FORWARDING LIC NO DPR-39 APPL FOR AMEND: TECH SPEC PROPOSED CHANGE CONCERNING  
REVISION TO THE CORE PROTECTION SAFETY LIMITS AND PROTECTIVE SYSTEM MAXIMUM  
ALLOWABLE SETPOINT CONTAINED IN SPECIFICATIONS 2.1 & 2.3...NOTARIZED  
06/26/78... W/ATT BAW-1493 REPT "Reload Rpt" Cycle 5, Oconee #1

PLANT NAME: OCONEE - UNIT 1

Reference: Oconee Nuclear Station, Unit 1  
Docket No. 50-269

Pursuant to 10CFR50, §50.90, please find attached proposed changes to the Oconee Nuclear Station Technical Specifications. These changes are required to support the operation of Oconee Unit 1 at full rated power during Cycle 5. This proposal consists of the following changes. The Core Protection Safety Limits and Protective System Maximum Allowable Setpoint contained in Specifications 2.1 and 2.3 respectively, have been revised. Specification 3.5.2.6 has been revised to incorporate xenon reactivity considerations for all three units. With the inclusion of this specification, Specifications 3.5.2.7 and 3.5.2.8 are renumbered. Table 3.5-1 has been revised to incorporate the new steady state tilt limit of 5.00% for Unit 1, Cycle 5.

CORE PROTECTION  
SAFETY LIMITS  
UNIT 1

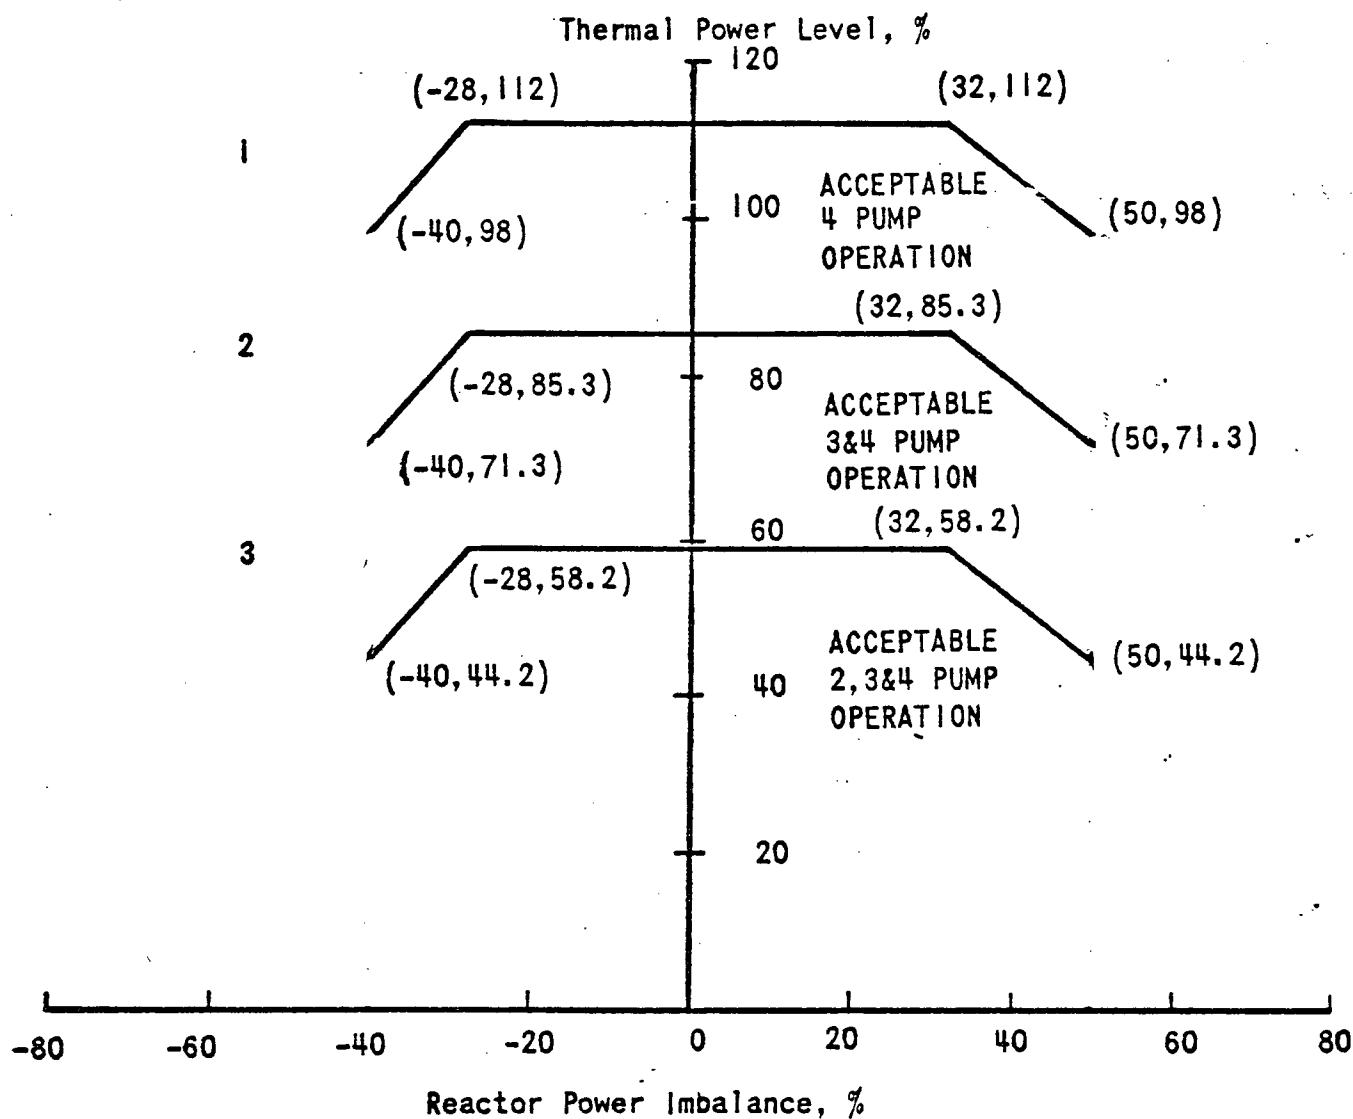
The curve presented in Figure 2.1-1A represents the conditions at which a minimum DNBR of 1.30 is predicted for the maximum possible thermal power (112 percent) when four reactor coolant pumps are operating (minimum reactor coolant flow is 106.5 percent of  $131.3 \times 10^6$  lbs/hr.). This curve is based on the combination of nuclear power peaking factors, with potential effects of fuel densification and rod bowing, which result in a more conservative DNBR than any other shape that exists during normal operation.

Figure 2.1-2A

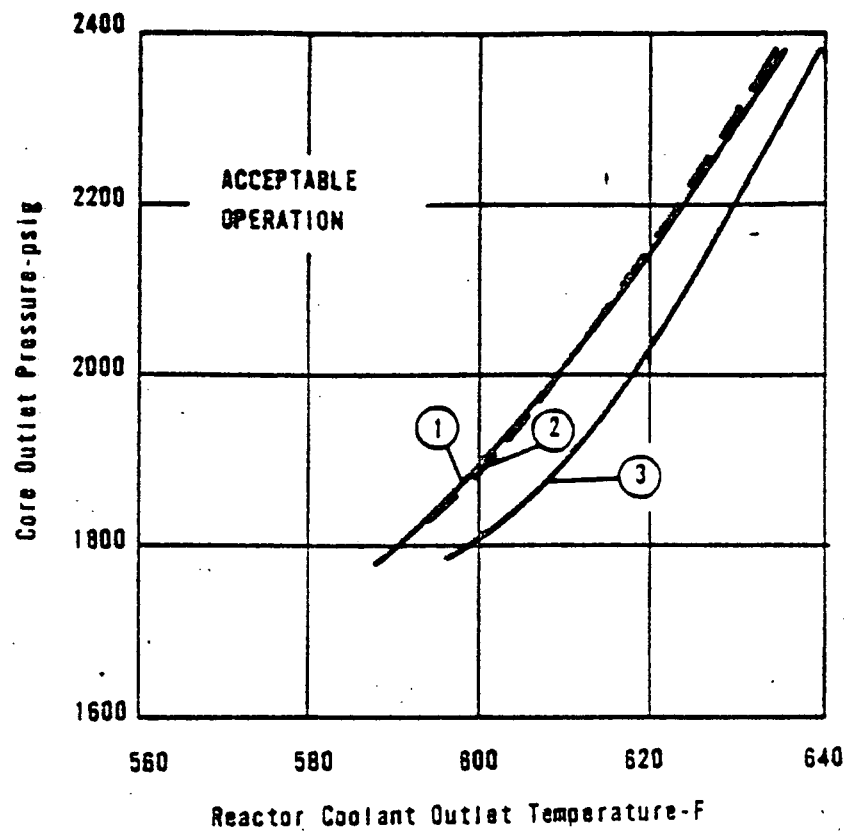
The curves of Figure 2.1-2A are based on the more restrictive of two thermal limits and include the effects of potential fuel densification and rod bowing:

1. The 1.30 DNBR limit produced by the combination of the radial peak, axial peak and position of the axial peak that yields no less than a 1.30 DNBR.
2. The combination of radial and axial peak that causes central fuel melting at the hot spot. The limit is 20.15 kw/ft for Unit 1.

The specified flow rates for Curves 1, 2, and 3 of Figure 2.1-2A correspond to the expected minimum flow rates with four pumps, three pumps, and one pump in each loop, respectively.

Figure 2.1-3A

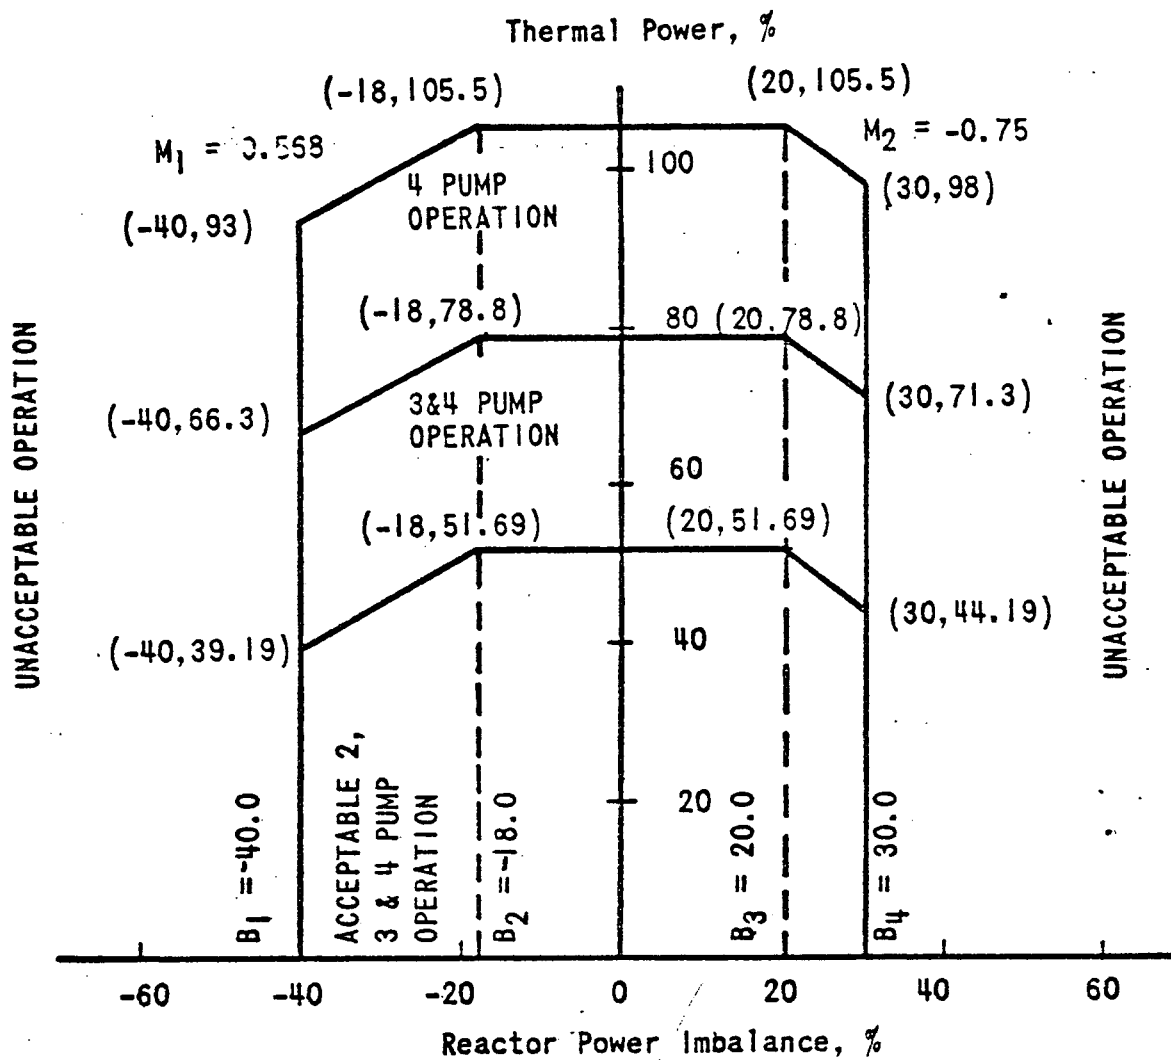
The curve of Figure 2.1-1A is the most restrictive of all possible reactor coolant pump-maximum thermal power combinations shown in Figure 2.1-3A.

The maximum thermal power for three-pump operation is 85.3 percent due to a power level trip produced by the flux-flow ratio  $74.7 \text{ percent flow} \times 1.055 = 78.8 \text{ percent power}$  plus the maximum calibration and instrument error. The maximum thermal power for other coolant pump conditions are produced in a similar manner.
